United States Patent and Trademark Office

APPLICATION NO.	FILING DATE	FIRST NAMED INVENTOR	ATTORNEY DOCKET NO. CONFIRMATION NO.		
10/780,633	02/19/2004	Johan Nilsson	0119-172 1888		
42015 7590 08/17/2007 POTOMAC PATENT GROUP PLLC			EXAMINER		
P. O. BOX 270			TAYLOR, BARRY W		
FREDERICKSBURG, VA 22404			ART UNIT	PAPER NUMBER	
			2617		
			MAIL DATE	DELIVERY MODE	
			08/17/2007	PAPER

DETAILED ACTION

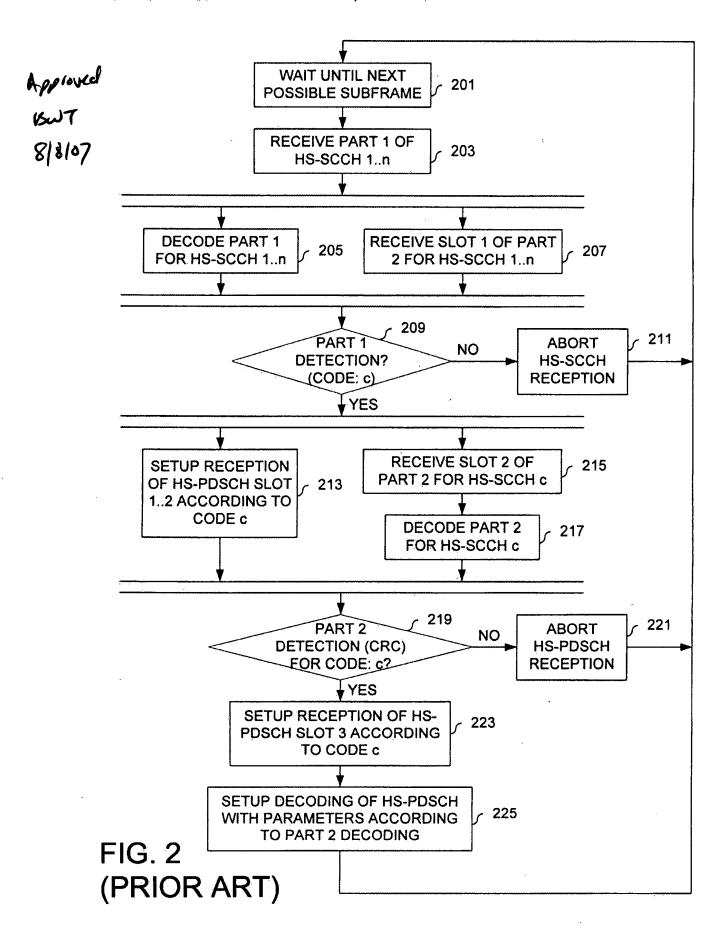
generating a correlation value by correlating the received part of the multi- part message with a known sequence (paragraphs 0006, 0007, 0017, 0032 – 0038, see "XOR" commonly used to correlate a received signal in CDMA – paragraphs 0039 – 0040 and **especially** block 209 in prior art figure 2 wherein paragraph 0043 clearly admits decision block 209 in already known to correlate the received HS – SCCH Part 1 information (i.e. multi-part message));

It appears from comparing Prior Art figure 2 and figure 5 that AAPA does not use threshold to compare correlation value blocks (see the only difference between figures 2 and 5 is using threshold blocks 513, 525 and 531 in figure 5).

logic that generates a correlation value by correlating the received part of the multi-part message with a known sequence (paragraphs 0006, 0007, 0017, 0032 – 0038, see "XOR" commonly used to correlate a received signal in CDMA – paragraphs 0039 – 0040 and **especially** block 209 in prior art figure 2 wherein paragraph 0043 clearly admits decision block 209 in already known to correlate the received HS – SCCH Part 1 information (i.e. multi-part message));

It appears from comparing Prior Art figure 2 and figure 5 that AAPA does not use threshold to compare correlation value blocks (see the only difference between figures 2 and 5 is using threshold blocks 513, 525 and 531 in figure 5).
